**MINUTES
CITY OF LAKEWOOD
BOARD OF BUILDING STANDARDS/
ARCHITECTURAL BOARD OF REVIEW/SIGN REVIEW
OCTOBER 10, 2019 at 5:30 P.M.
LAKEWOOD CITY HALL
AUDITORIUM**

**15000 Detroit Avenue
CBD American Shaman**

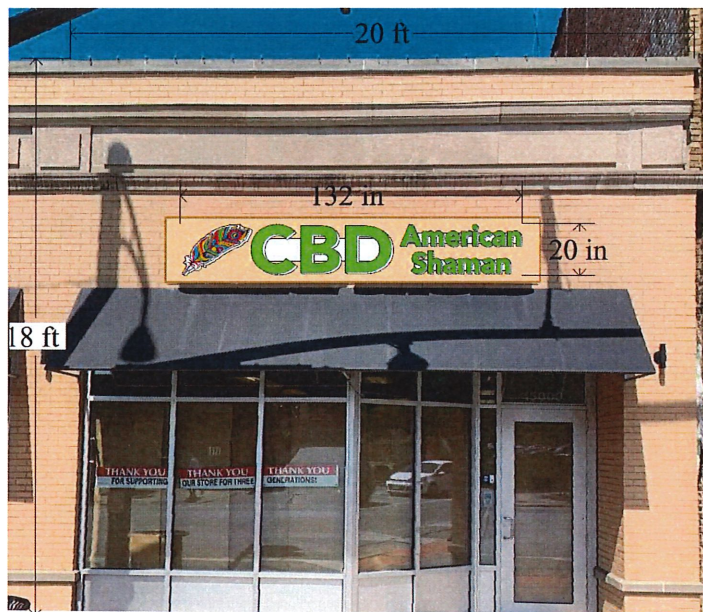
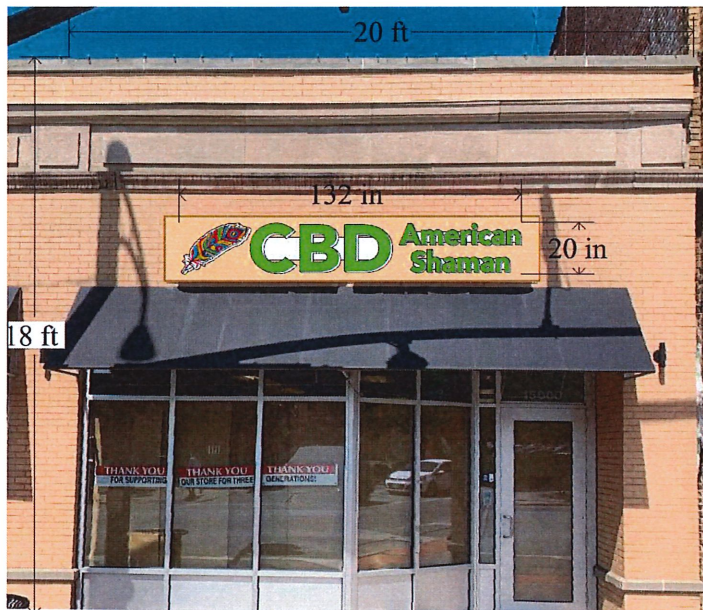
Krusa Ortiz, representative was present to explain the revised application. The board asked about sizes, colors of the sign board and the window signs. Public comment was closed as no one addressed the item.

- Raceway is painted to match the backing/building.
- The two cross graphic signs are the same size (2.2 feet).

**13425 Detroit Ave
O'Leary Dental**

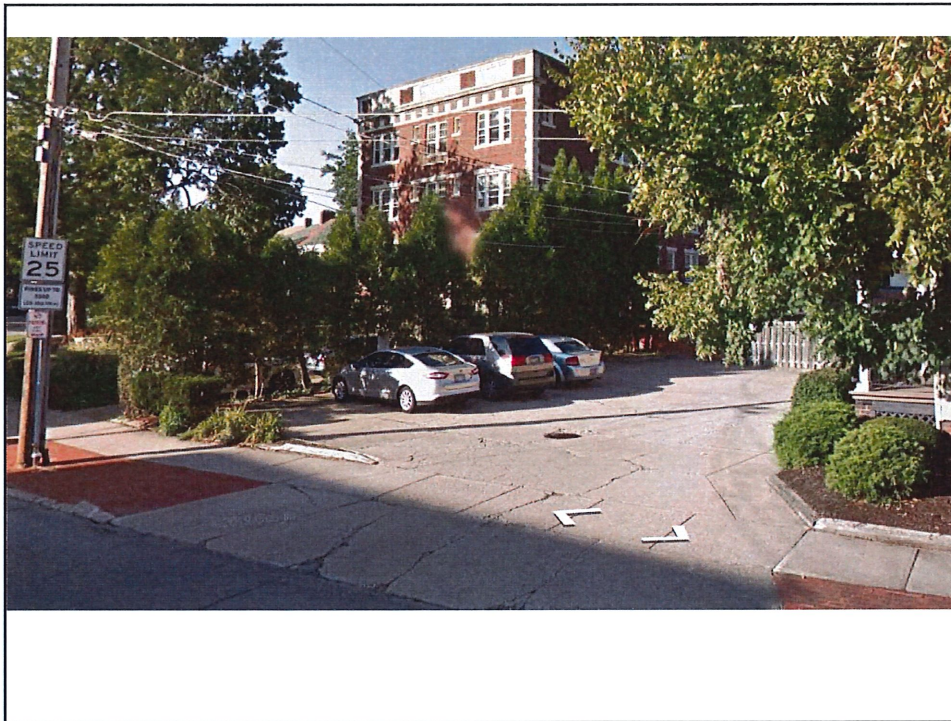
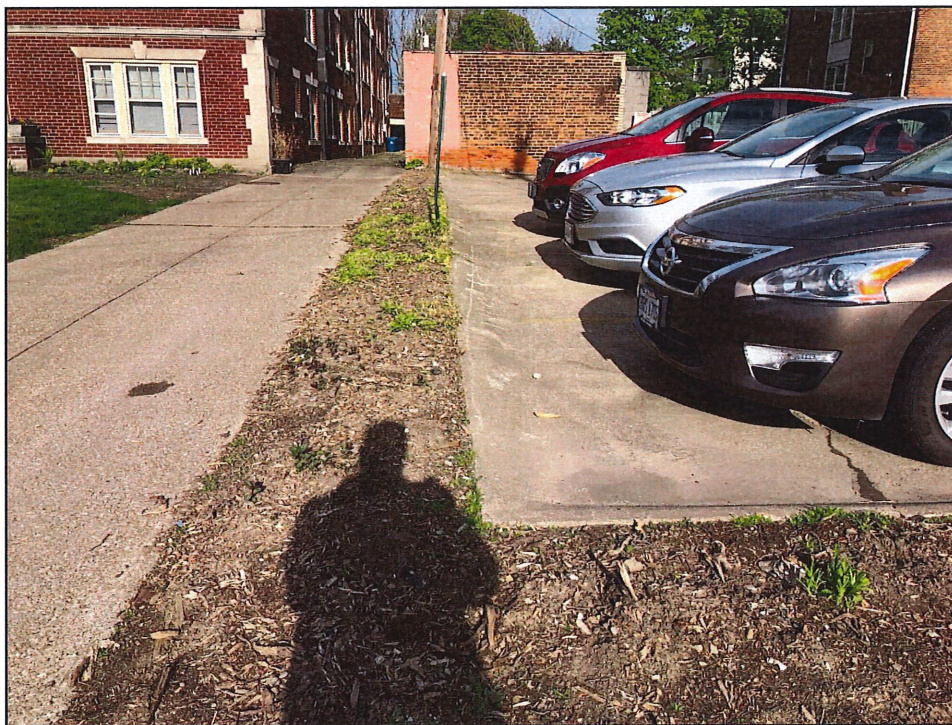
Kate O'Leary, applicant was present to explain the request. Staff cited Code section 1325.08 Parking and Vacant Lot Design which specifies that a 48" tall solid barrier must be constructed where commercial properties are adjacent to residential ones. The board said the fencing should be solid, asked about lighting, did not want to set a precedent of allowing non-solid fencing in this area. Public comment was closed as no one addressed the item.

A motion was made by Ms. Haney, seconded by Mr. Grambort to **DENY** the request. All the members voting yea, the motion passed.

17822 Lake

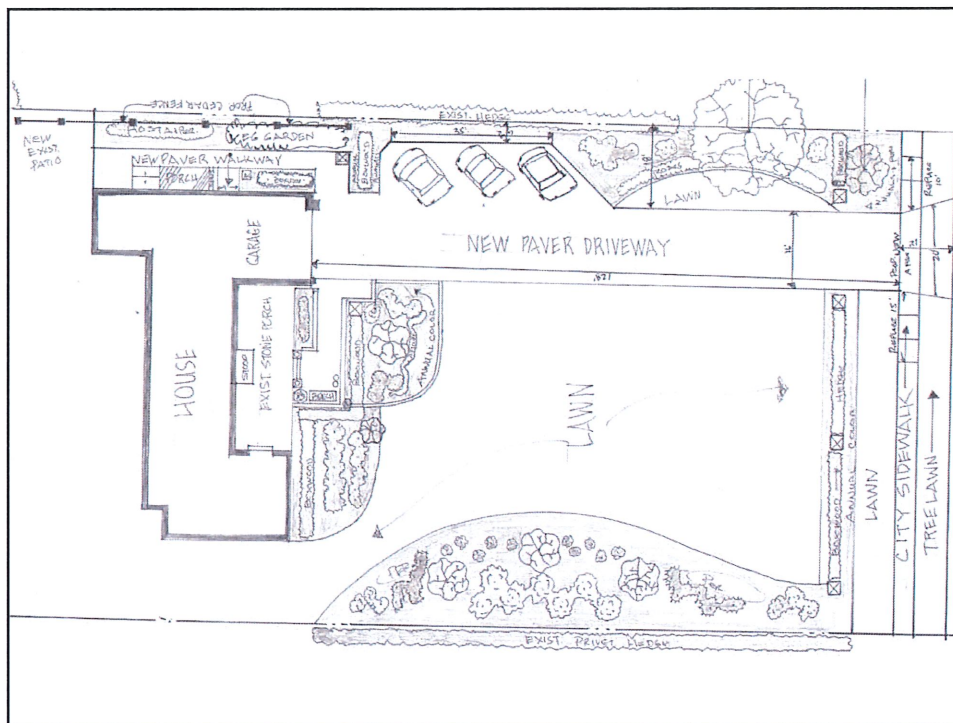
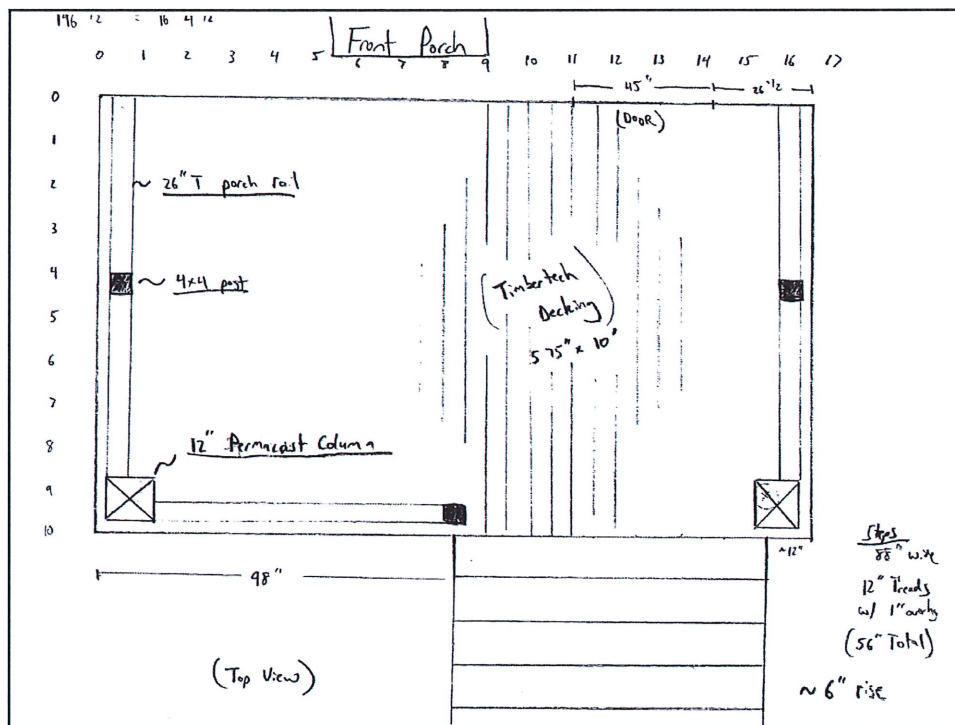
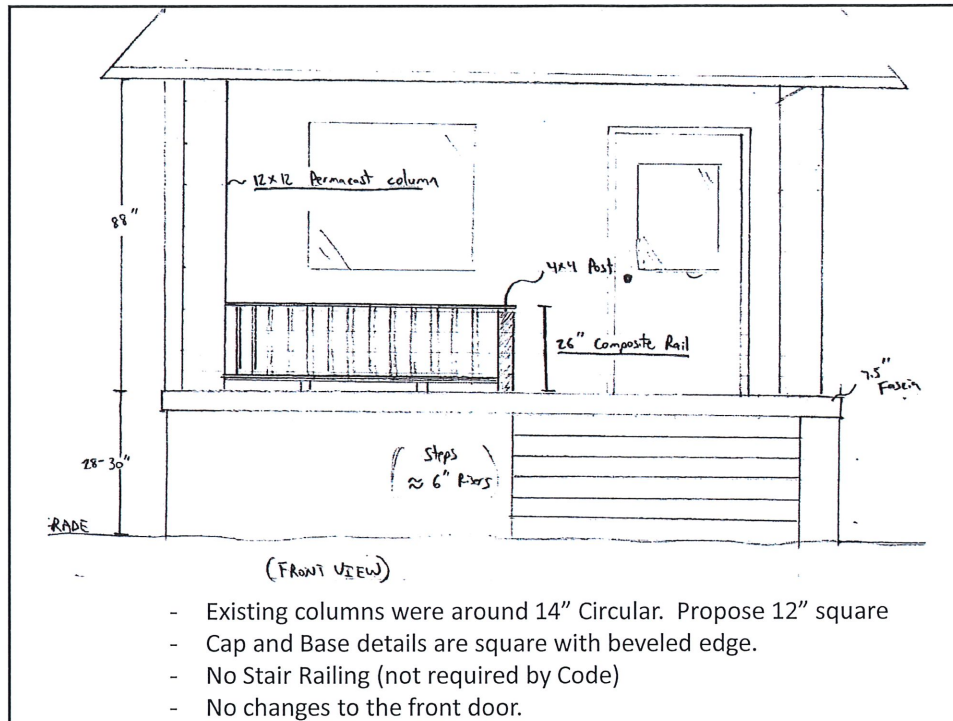
Lisa O'Brien, property owner was present to explain the request. There was discussion about the pillars/piers, brick, light fixtures, landscaping. Public comment was closed as no one addressed the item. Staff supported the request.

The contractor and homeowner from 17822 Lake Road were present to discuss their project. The Board clarified several items related to the landscape columns, extended front porch, and expanded parking area.

- The light fixtures are approved administratively.
- The two pillars at the driveway are 6 feet tall, and all other ones are 4 feet tall.

**12600 Berea Road
NSC Lakewood**

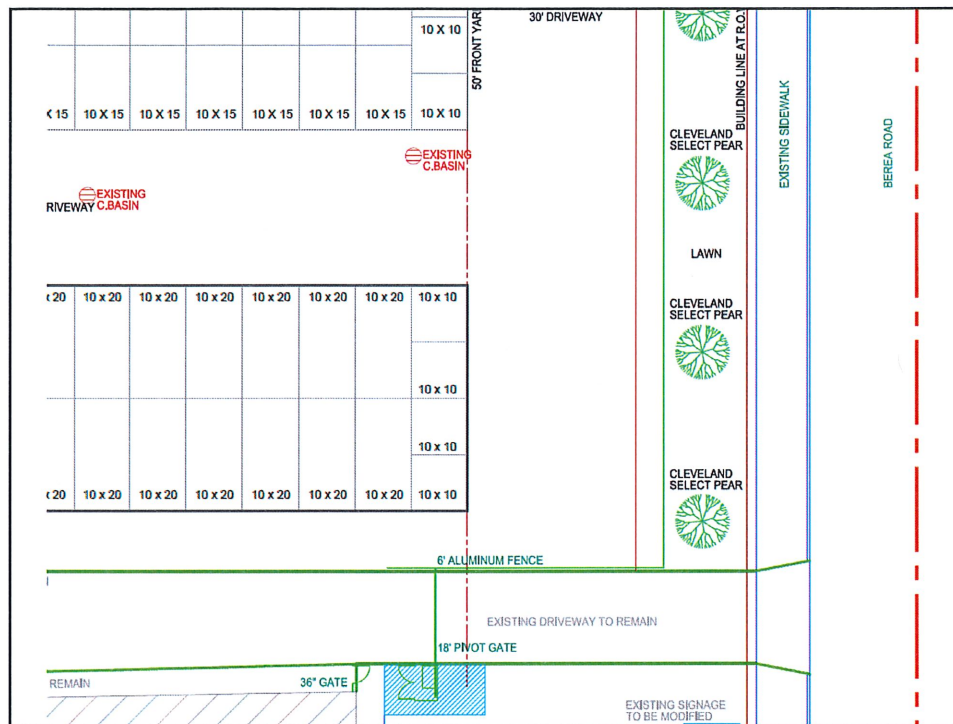
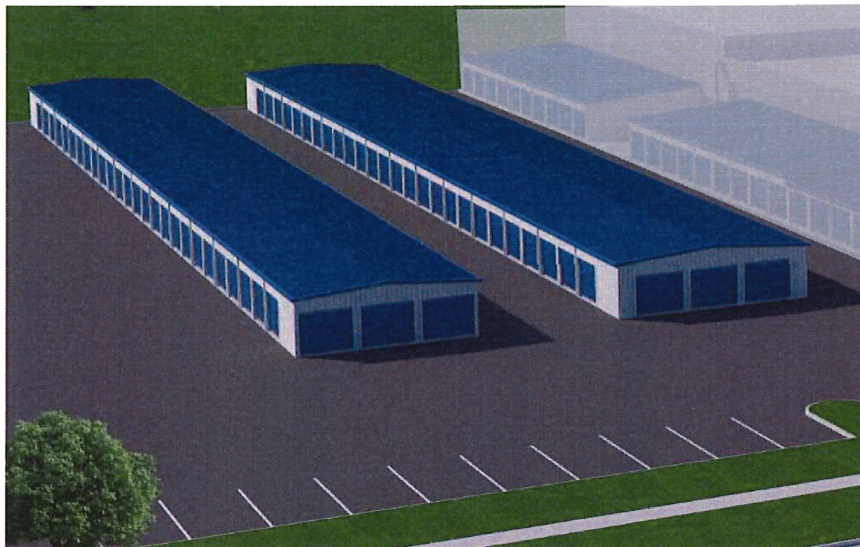
Jim Jakubus, Pogoda Co., applicant and Adam (no last name noted) were present to explain the requests. A lot consolidation request would be submitted to the City's Planning Commission. Discussion ensued about fencing, colors on the Berea Road facing garage doors, stormwater retention, lighting, stain color for repair of blond concrete, dimensions of the storage buildings, signage.

- Any Berea Road facing garage doors would be painted white to match the metal of the buildings.
- Any replacement brick on the blond building would be stained to match in color as closely as possible.

- Remove the unapproved vinyl graphics in the second-floor windows.
- The blue canopy matches the detail sheet.
